Re: Villas at Ingram Hills POADP # 661

THE VILLAS AT INGRAM HILLS

PLANNED UNIT DEVELOPMENT • P.O.A.D.P.

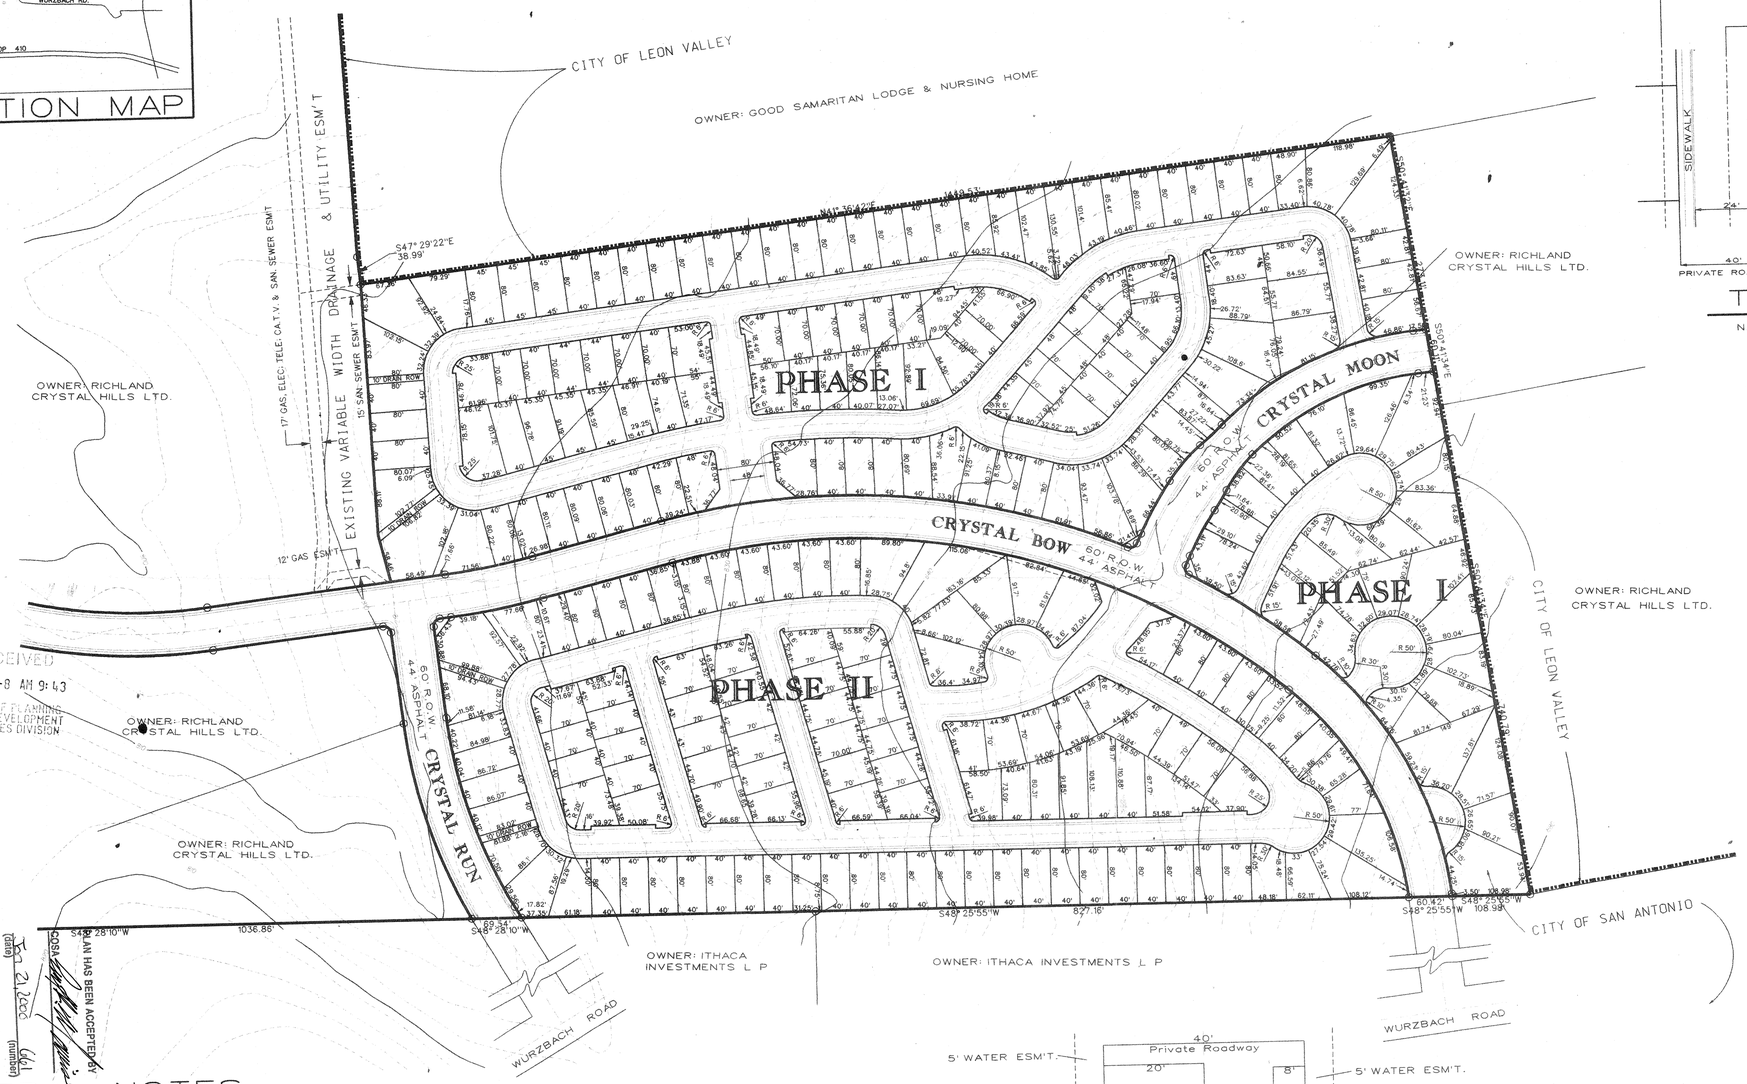
- Based on the topography, a Flood Plain Study and drainage review will probably be required during the platting process. Bexar Co. Public Works will require base flood elevations at the plat level.

- It will be expected that you will plat all of the property depicted in your POADP, to include: floodpains, drainage areas and open space.

- The Engineering and Traffic Division has conducted numerous traffic studies within this area. Due to inadequate connectivity between Grissom and Wurzbach, recommendations are towards a 60 ft. right-of-way dedication on the west portion of this development in order for future connection of Crystal Run into Shadow Mist. For additional information about these requirements you can contact Public Works at 207-7587.
